From: Mark Kirk *RES*
To: Jon Hopkins; Steven Long *NRR*
Date: 8/26/02 2:32PM
Subject: RE: NRC Request re: Cavity Mold

I recently received the attached photo (via Steve Long) of the casting that was made from the davis besse cavity.

Based on the photos (particular slide #12) in the 6/17/02 presentation at BWXT and photos for the exposed cladding area measurement (word doc in my 8/7/02 email to you), the shortest distance from the nozzle #3 O.D. to the extremity of the cavity (i.e. the farthest point of the nose) is estimated to be 5.9+/- 0.2 inch.

Kirk's interpretation: In the photo above:

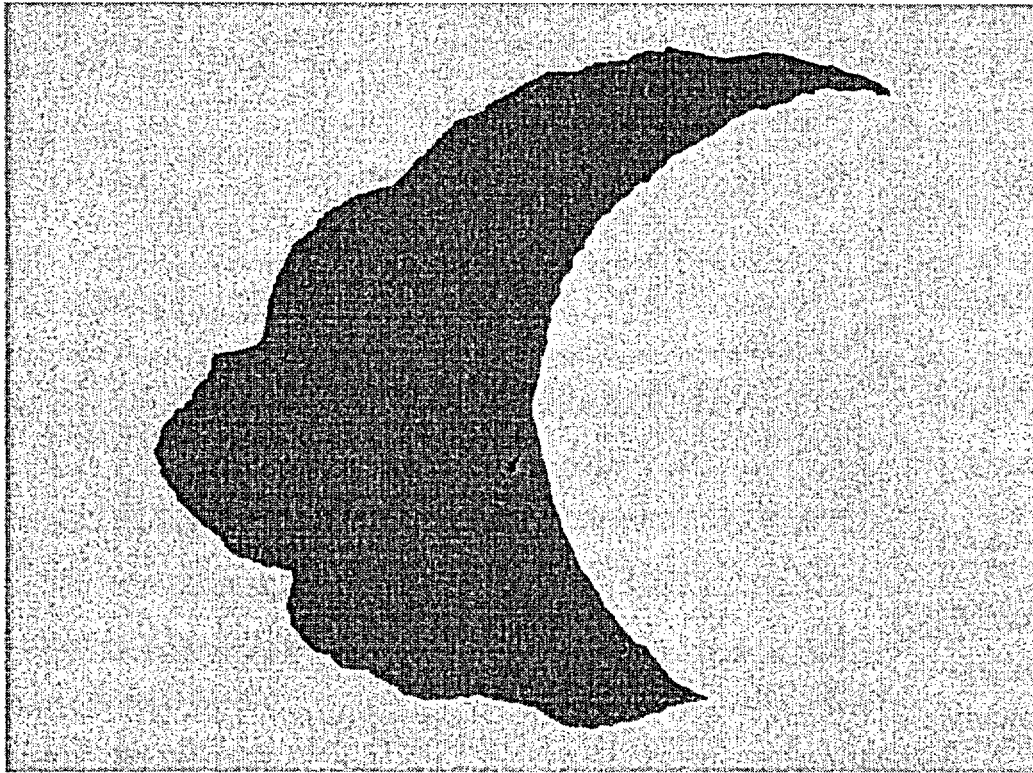
From viewing the cavity and the mold that is the subject of the photograph, I am sure that your interpretations about what-is-what are correct. Since the photo seems to be carefully controlled to have the cast of the exposed surface parallel to the film plane, i expect the area measurement is reasonably close to the righ tvalue. However, I'm not so sure about the rest of the things one might scale off this photo or others of the cavity.

1. Could you please open the attached file and make sure that i have interpreted the photo correctly (see the lines i have drawn on the photo and the text that is in the box just below the photo. I want to compare measurements that we can digitize off of this with the cavity our contractors have modelled in their stress analysis.

- The blue curve is the OD of the nozzle
- The area between the red and the blue curves is where the J-groove weld was
- The area between the red and the lime green curves is the area where the cladding was COMPLETELY un-backed by reactor pressure vessel steel.
